Environmental Impact Statement

Accelerator Production of Tritium at the Savannah River Site

**Final
March 1999**

TITLE: Final Environmental Impact Statement: Accelerator Production of Tritium at the Savannah River Site (DOE/EIS-0270)

Figure 3-4. Land forms, topography, and 100-year floodplain of the preferred and alternate sites. The footprint of the modular design variation is superimposed over the baseline APT footprint at each site.

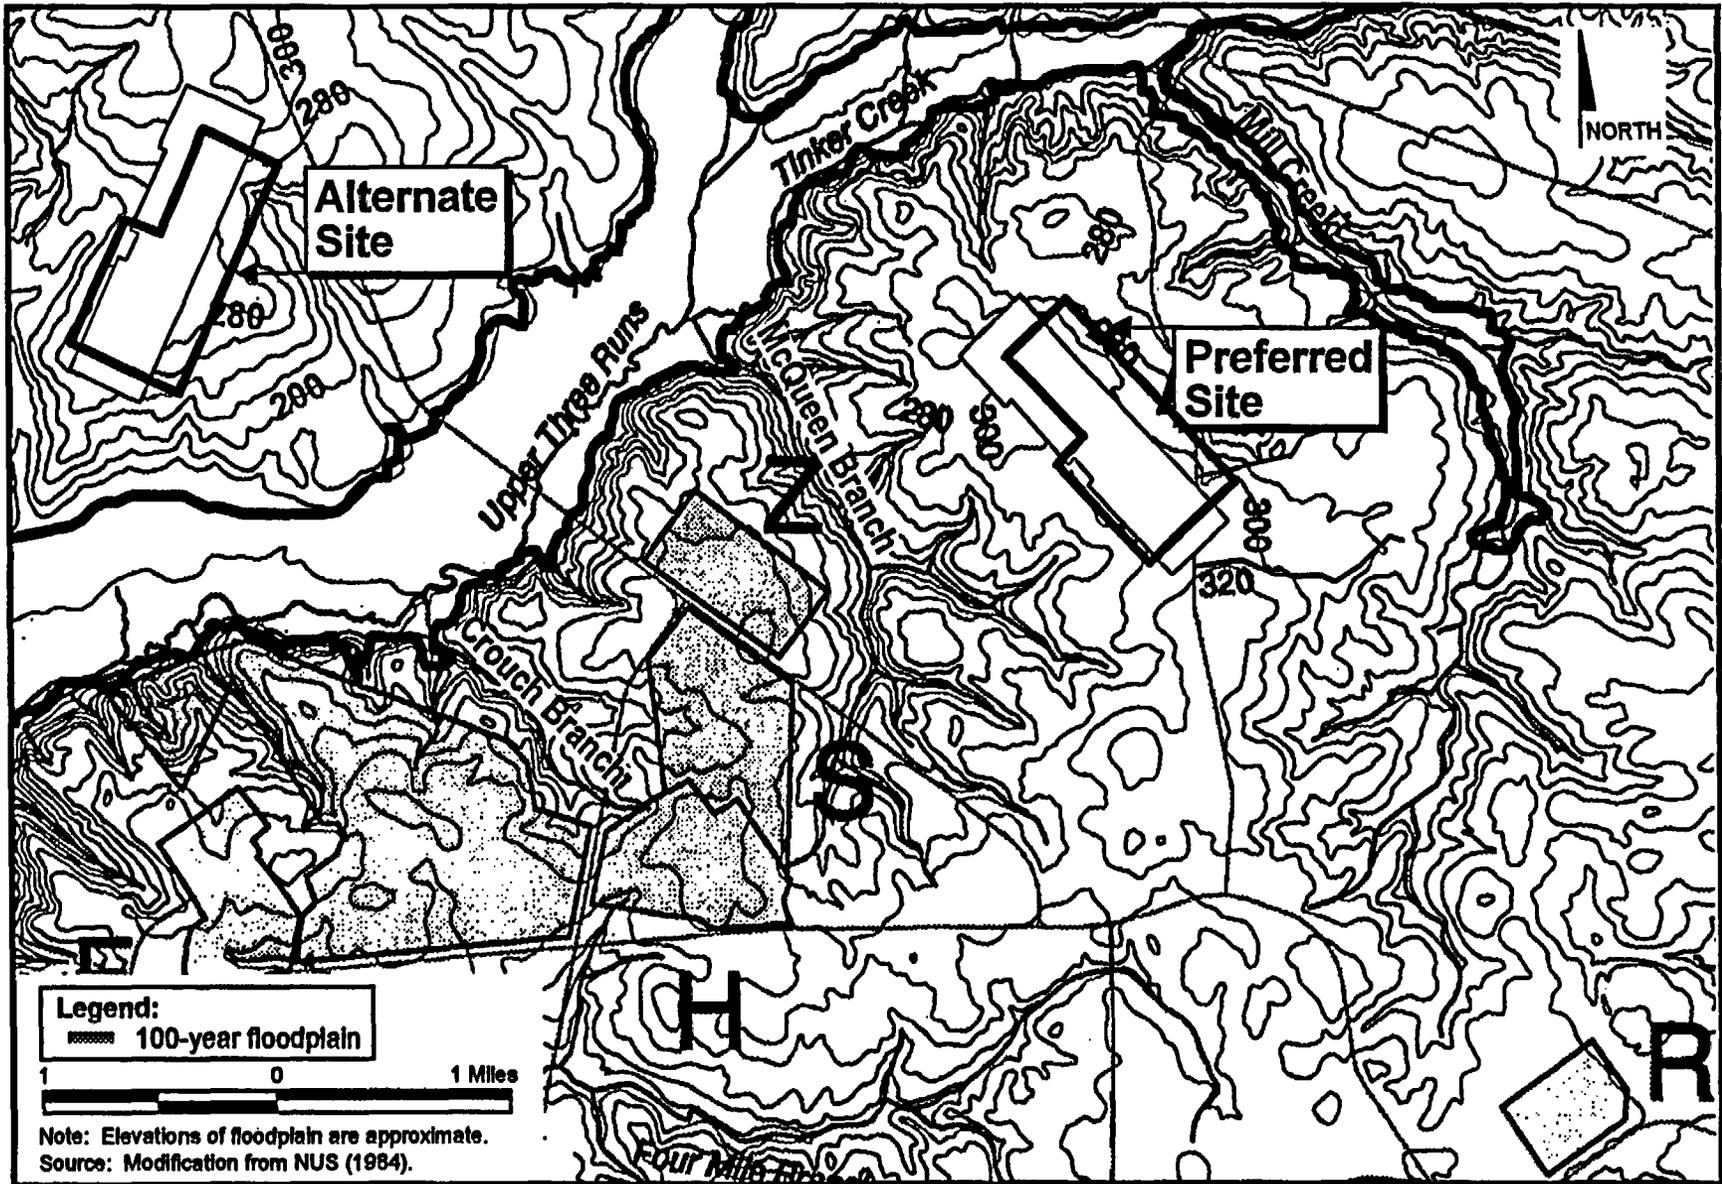
Page 3-6, 1st column, 3rd paragraph and Figure 3-4 on page 3-7 are replaced by the following:

Both the preferred and alternate APT sites are on relatively flat, broad and sandy upland areas typical of the Aiken Plateau portion of the Savannah River Site that formed in deep beds of marine sediments (Wike et al. 1994). The orientation of the APT footprint on the preferred site is from southeast to northwest; the footprint orientation on the alternate site from southwest to northeast. Figure 3-4 shows the locations of the sites and their surface features (topography and nearby surface waters). The footprint variation for the modular or staged accelerator design is also shown. As can be seen, the modular design variation would result in a

Figure 3-5. Soil types at the preferred APT site.

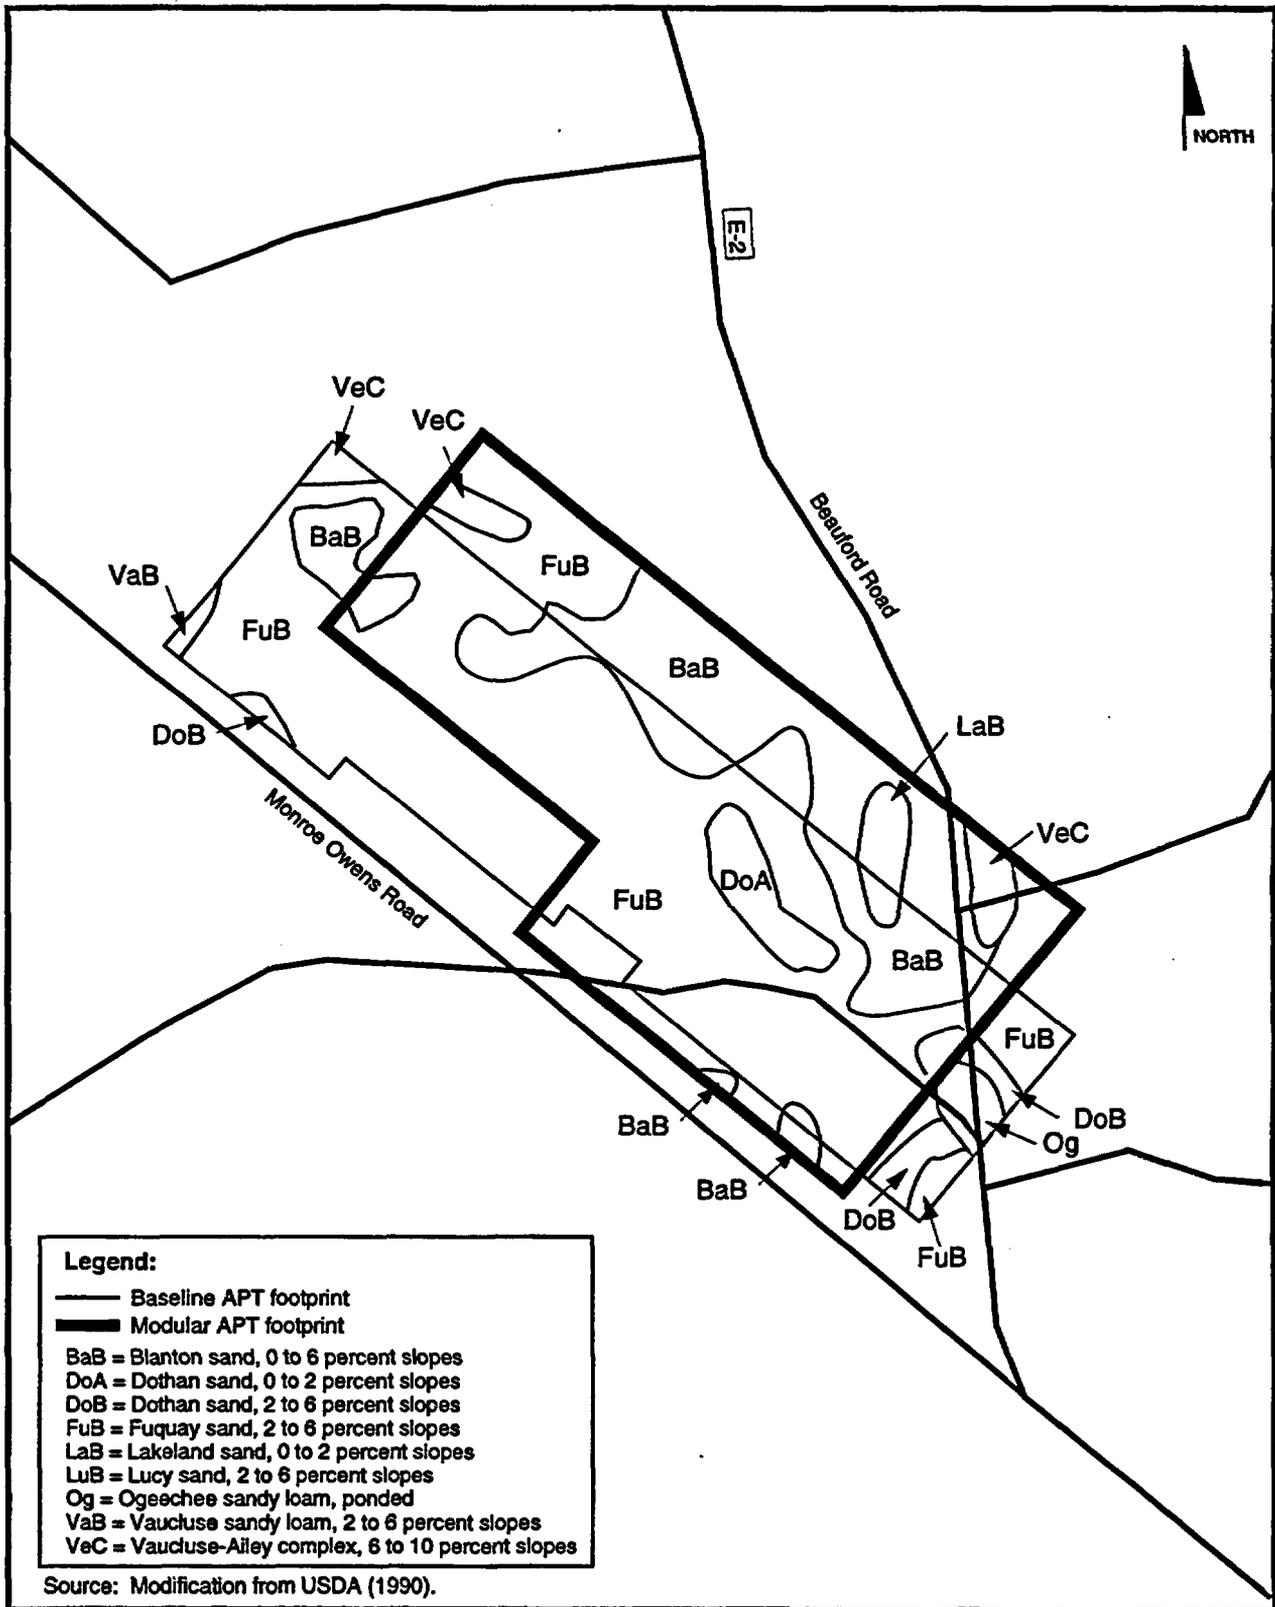
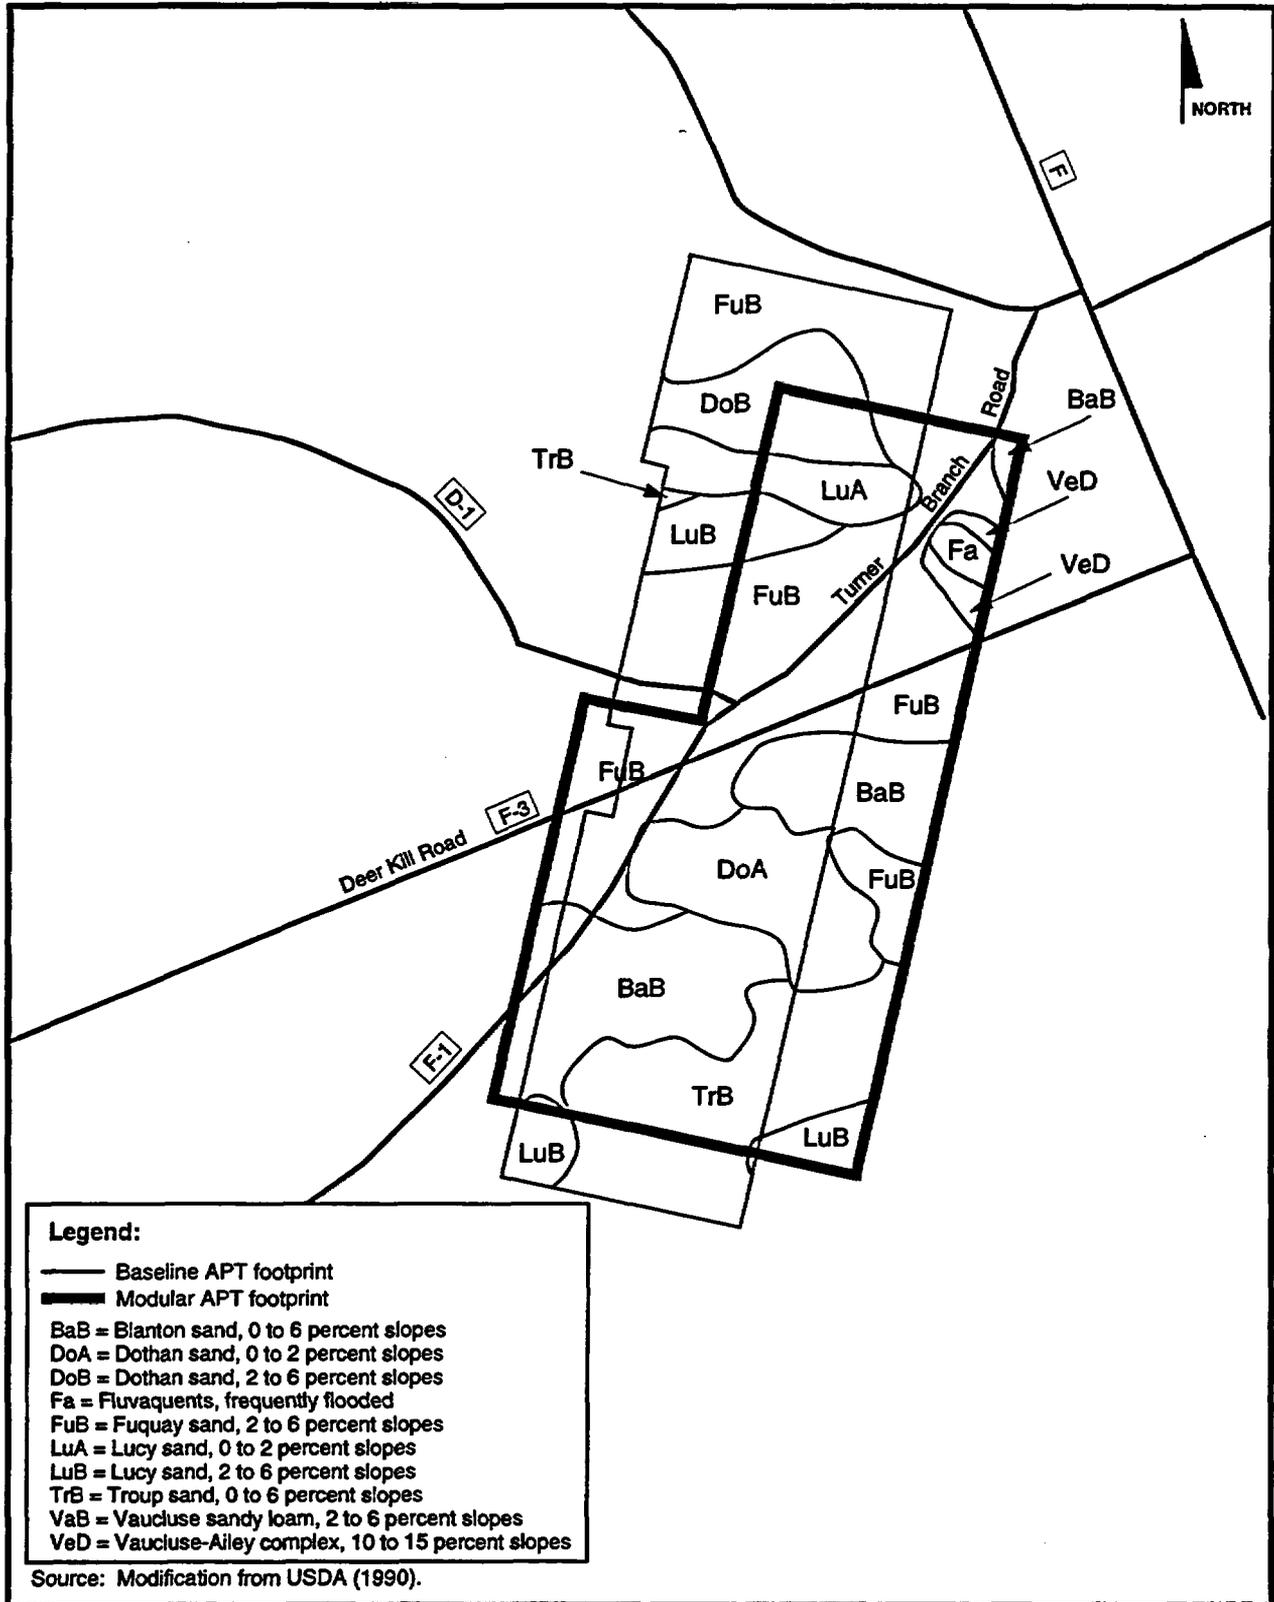
Page 3-8, 1st Column, 1st paragraph, 5th through 9th lines, Figure 3-5 on page 3-9, and Table 3-1 on page 3-10 are replaced with the following:

Figure 3-5 and 3-5a, soil maps for the preferred and alternate sites, show the boundaries of the soil mapping units. The footprint variation for the modular or staged accelerator design is also shown. In the case of the modular design footprint, the preferred site would have predominantly Blanton and Fuquay sands.

Figure 3-16. Forest cover of preferred APT site.

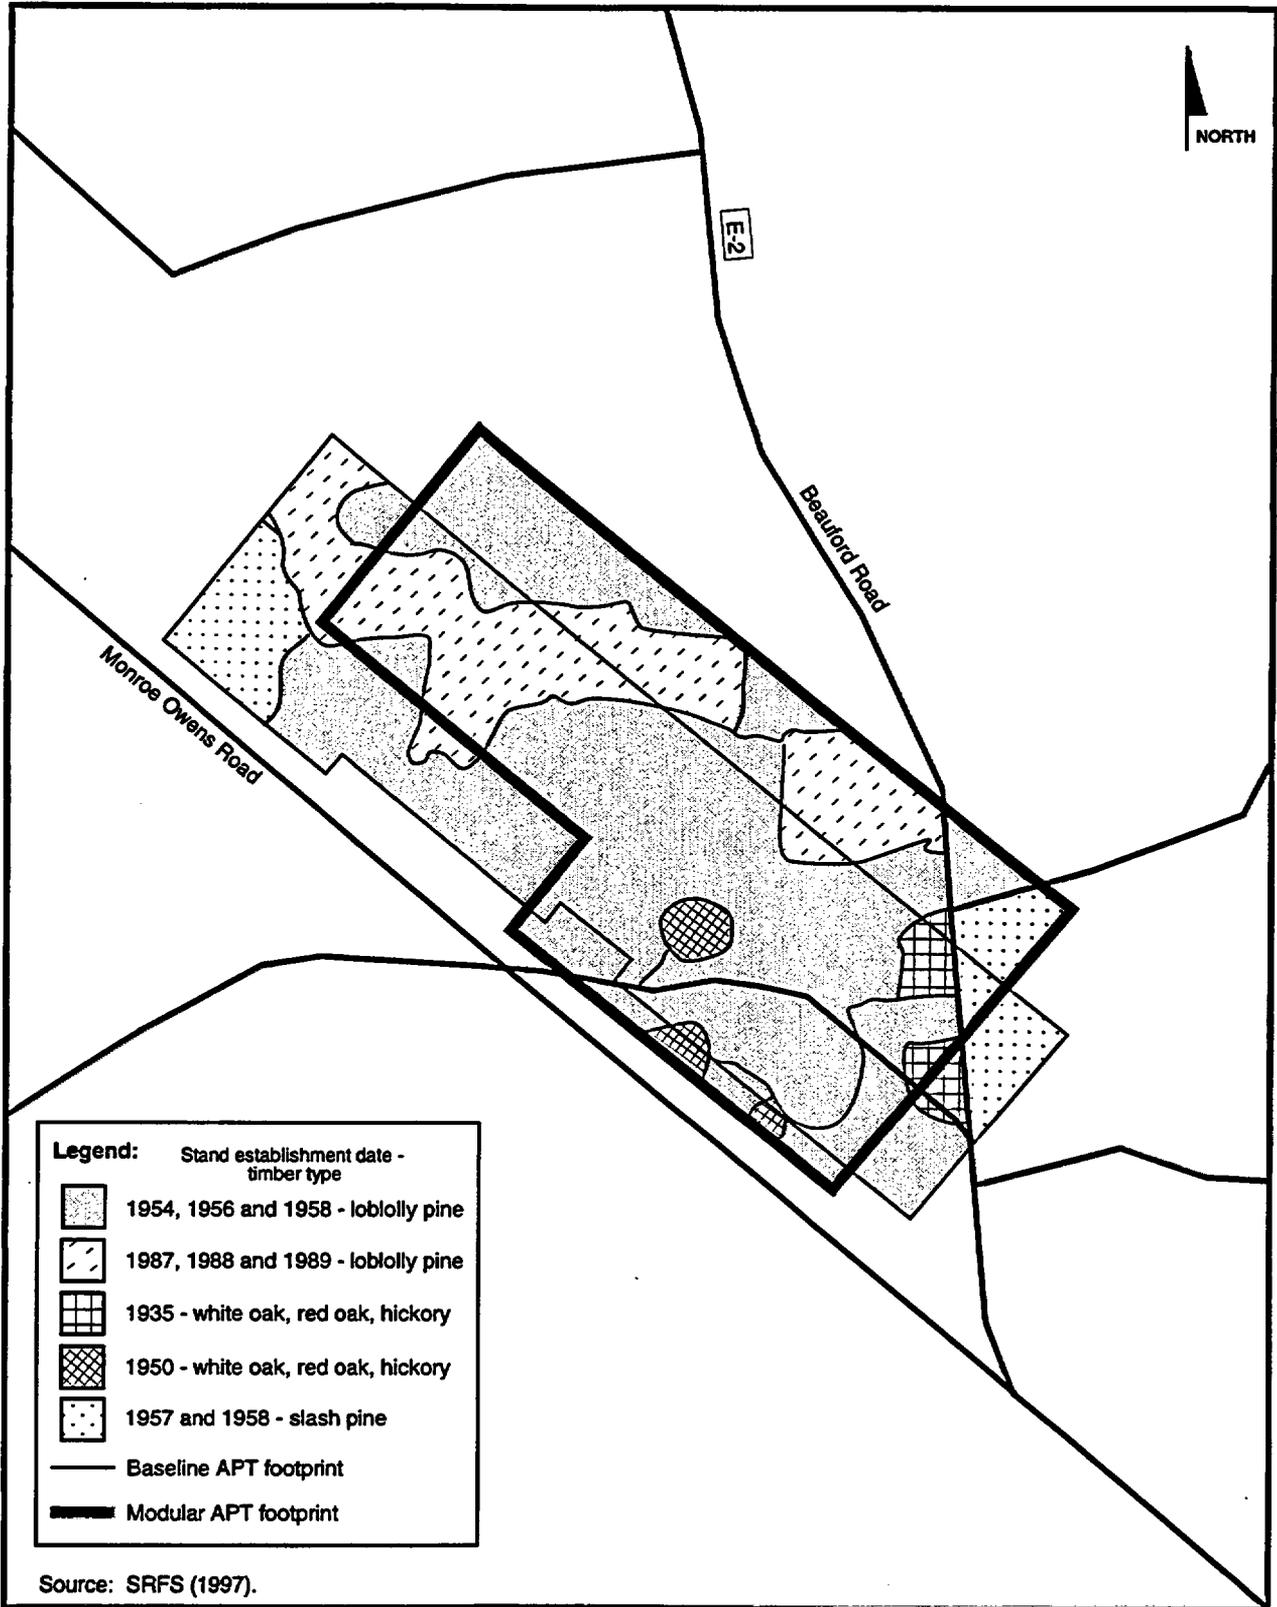
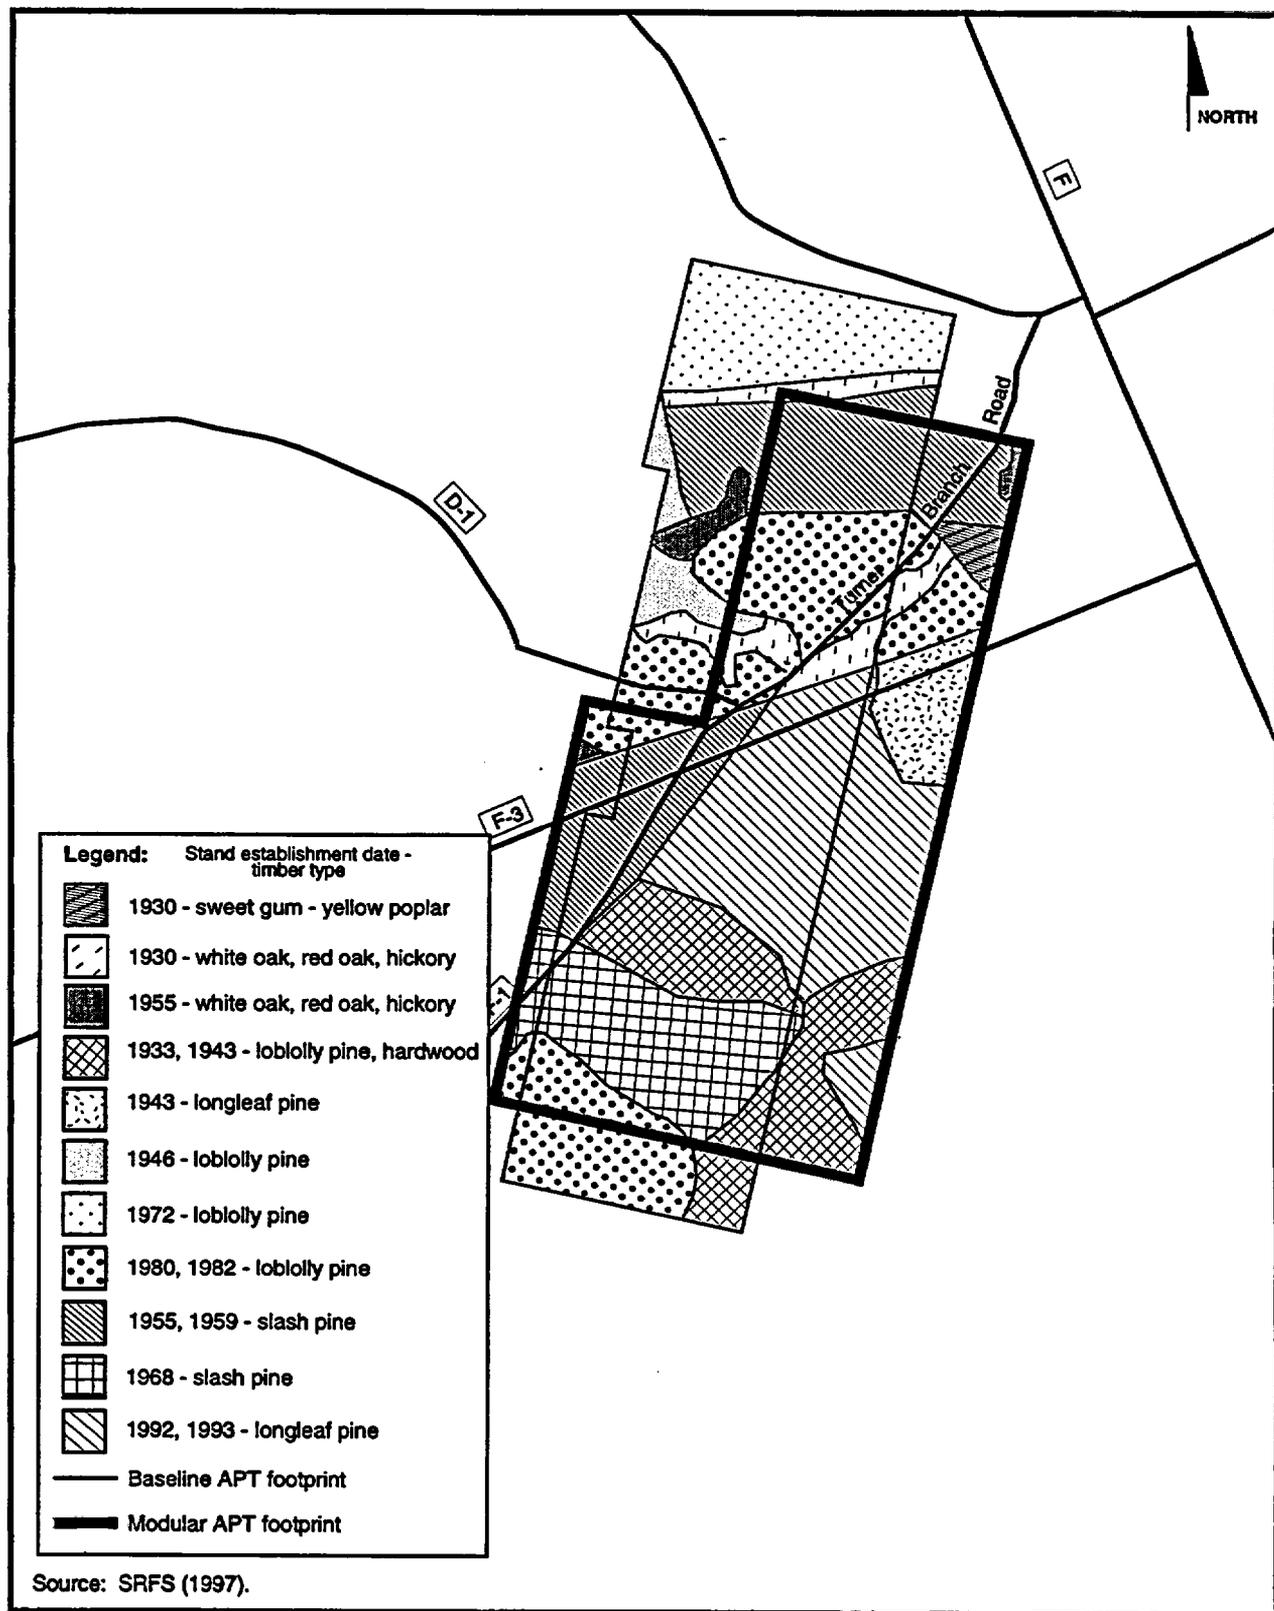
Page 3-44, 1st Column, 1st paragraph, lines 2 through 15, and Figures 3-16 and 3-17 on pages 3-47 and 3-48 are replaced with the following:

Both sites also have small pockets of 40- and 60-year old upland hardwood stands of white oak, red oak, and hickory ranging in size from 8 to 12 inches in diameter (SRFS 1997). Understory species found on the preferred site include vacciniums (blueberries), sparkleberry, hickories, laurel oak, water oak, southern red oak, sweetgum, black cherry, persimmon, sassafras, and winged sumac. Ground cover includes Japanese honeysuckle, yellow jessamine, greenbrier, muscadine grape, spotted wintergreen, various grasses, legumes, and composites (SRI 1998). Figures 3-16 and 3-17 show the forest cover types of each site. The footprint variation for the modular or staged accelerator design is also shown. In the case of the modular design footprint, forest cover of the preferred site will be virtually the same as with the baseline footprint. On the alternate site, more acres of longleaf pine and mixed loblolly pine hardwood stands will be included in the modular design footprint.
